Modifications Notices

Signal Relays

No. YPE-G3VM-0399-2B

Changing marking on products for traceability and pin-1 identification improvement of Modification Notice.

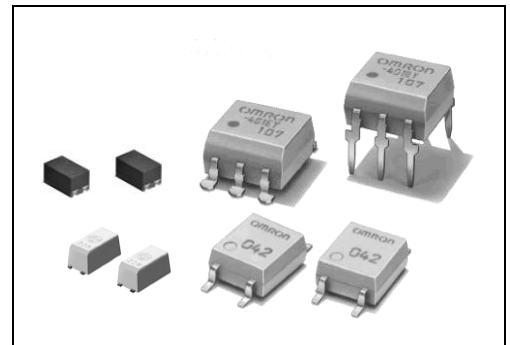
Traceability code addition

Pin-1 mark change

Effective date change February 2019

All models in the list

SOP models only

DIP models only
